To: Sam Foster
Copy:
From: AG
Date: 7 February 2017
Job Number: 17_98

SUBJECT: Lakeside Plan Change 20 - Submissions

Traffic

Figure 1: Proposed Crossroads

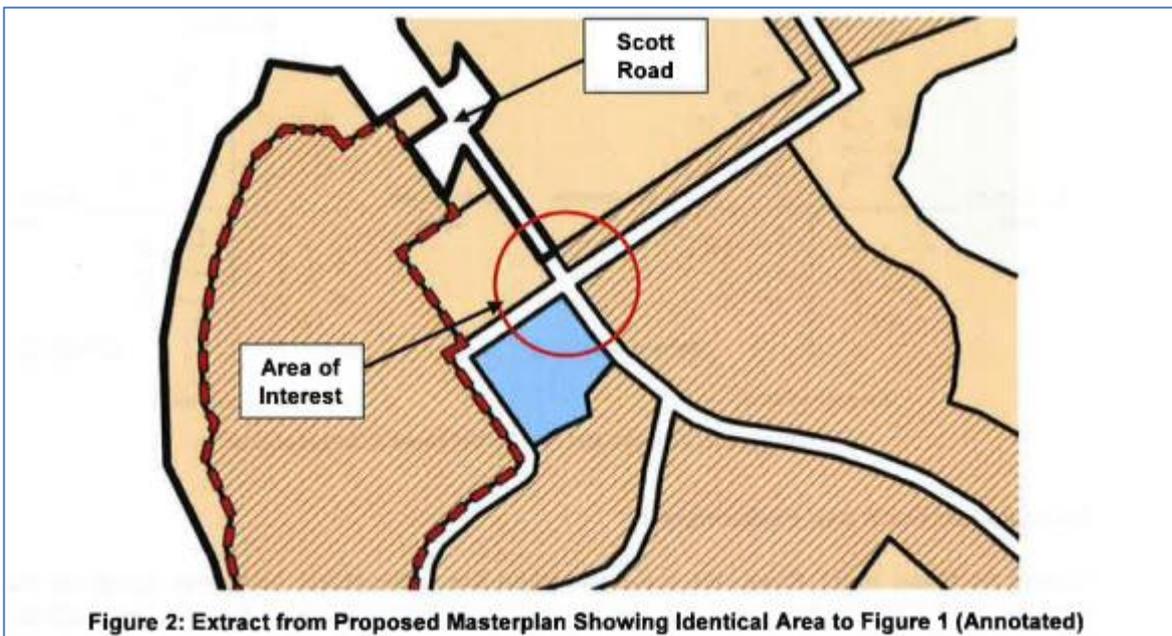
The submission proposal is for a cross-roads instead of a staggered tee at the commercial centre as notified.

A supplementary assessment letter from Andy Carr explains and supports the change. The letter notes that additional land may be required to accommodate an appropriate intersection form (assessment based on roundabout).

I am happy with the assessment and consider that the cross roads layout is satisfactory. I suggest that the information requirements for a subdivision application require a preliminary design to demonstrate space to allow the intersection to be constructed for safe and efficient operation for all users (e.g. pedestrians, cyclists and local property access).

In summary, I support the submission.
